## ARCHITECT'S ADDENDUM

ADDENDUM NUMBER: 001

RE: Kane County  
Courthouse Parapet Repair

Subject: Addendum No. 001 to the Construction Documents for the Kane County Courthouse Parapet Repair project.

1 STREETSIDE ELEVATION: NORTH  
1/16" = 1'-0"

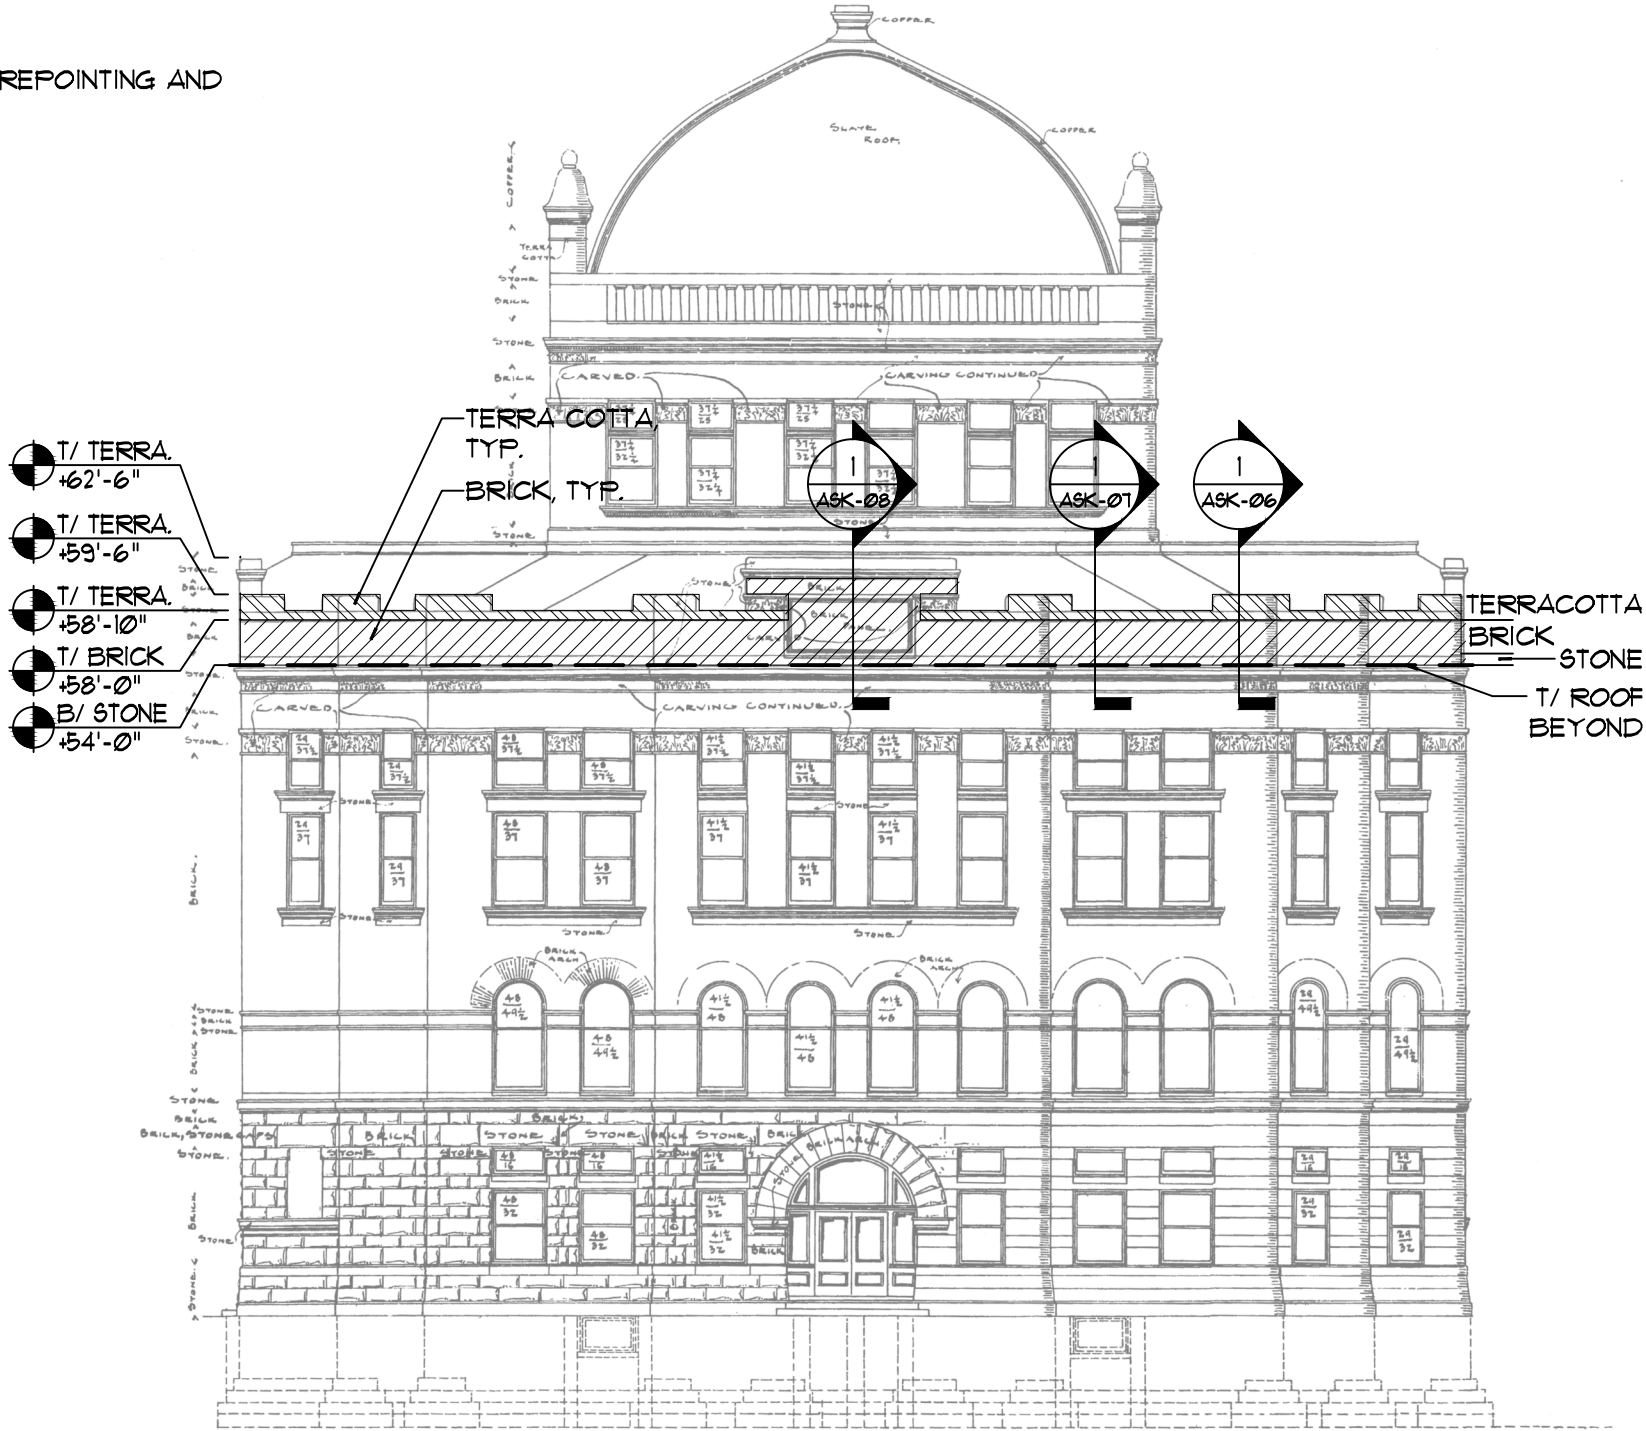
5. ASK-07: Clarification: Brick identified to be removed, salvaged and reused is a part of the base bid. Half-toned brick in the the middle and street-side wythe are subject to unit price / allowance.
6. ASK-08: Clarification: Brick identified to be removed, salvaged and reused is a part of the base bid. Half-toned brick in the the middle and street-side wythe are subject to unit price / allowance.
7. ASK-08: Modify: Replace reference to "Profile D" with "Profile F"
8. ASK-14: Add: See attached.
